MIL-S-20708/64B(OS)  
NOTICE 1  
29 February 1988

SYNCHRO TORQUE DIFFERENTIAL TRANSMITTER,  
TYPE 31TDX4C

MILITARY SPECIFICATION SHEET  
SYNCHRO TORQUE DIFFERENTIAL TRANSMITTER, TYPE 31TDX4c

This amendment forms a part of Military Specification MIL-S-20708/64B(OS) of 3 March 1969, and is approved for use by all Departments and Agencies of the Department of Defense.

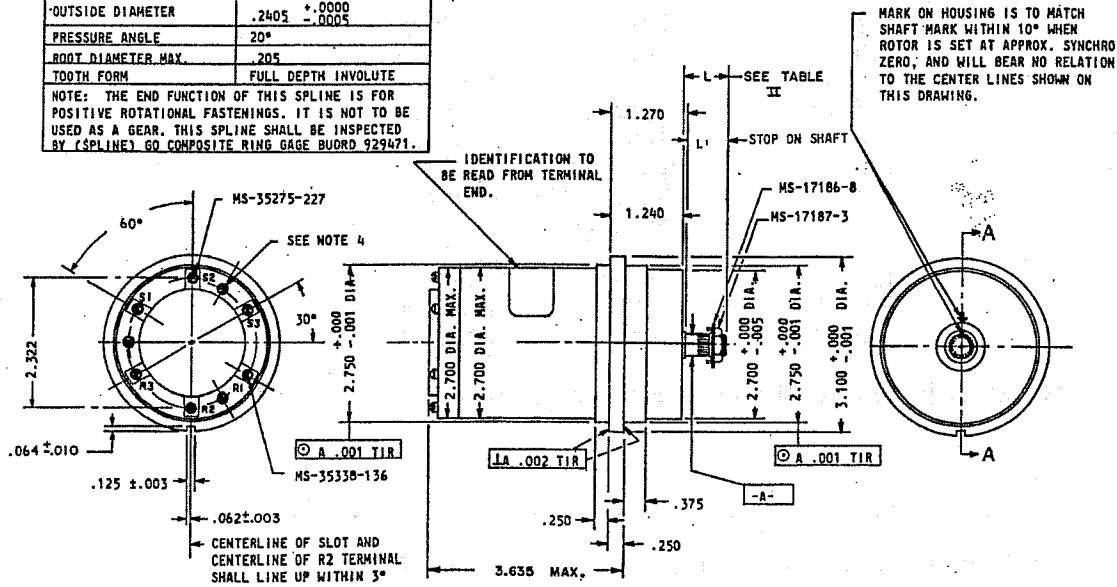
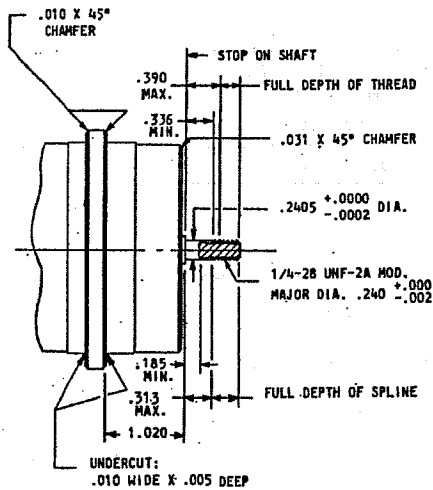
Outline drawing, flange diameter designation 3.100 (+.000 -.001): Delete the tolerance "(+.000 -.001)" and substitute the tolerance "(+.000 -.005)".
